UNITED STATES PATENT AND TRADEMARK OFFICE

APPLICATION NO.	FILING DATE	FIRST NAMED INVENTOR	ATTORNEY DOCKET NO.	CONFIRMATION NO.
10/693,699	10/27/2003	Farid Bruce Khalili	VER2226-002	2292
8698	7590	08/24/2007	EXAMINER	
STANDLEY LAW GROUP LLP			SWIGER III, JAMES L	
495 METRO PLACE SOUTH				
SUITE 210			ART UNIT	PAPER NUMBER
DUBLIN, OH 43017			3733	
			MAIL DATE	DELIVERY MODE
			08/24/2007	PAPER

Office Action Summary

DETAILED ACTION

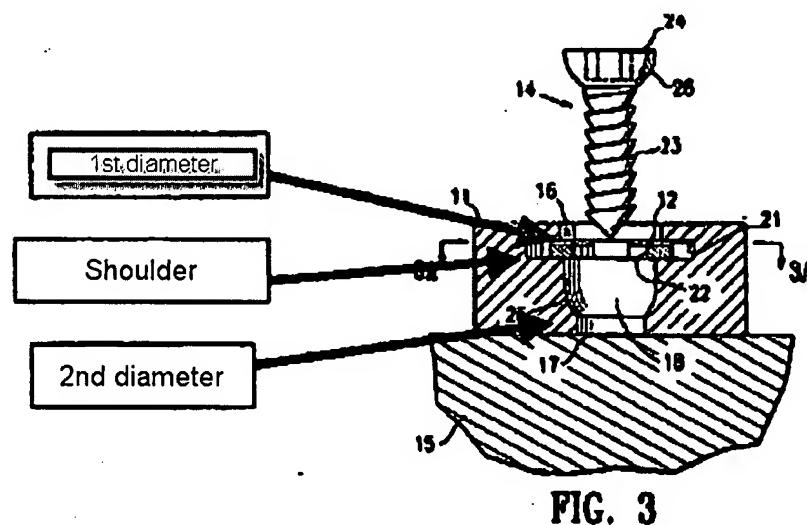
Claims 58-63 are rejected under 35 U.S.C. 103(a) as being unpatentable over Talaber et al. (US Patent 6,261,291) in view of Warden et al. (US Patent 5,261,910) and Bono (US Patent 5,954,722). Talaber et al. disclose an orthopedic implant assembly comprising a screw retention member (11) having a bore formed therethrough (13) with a first and second diameters (see drawing below).

Talaber et al. also disclose a tapered retention seat (34) along an intermediate portion of the passageway, a split ring (22) that has inside and outdoor diameters that allows for expansion, that is also removably seated in the retention seat (21) that is capable of rotating engagement with the fastener (14) and being moved by the rotation of the fastener. Talaber et al. also disclose a fastener with a shaft (proximate to 23) and a head at one end, the head being generally spherical, and wherein the shaft is threaded for purchase of bone.
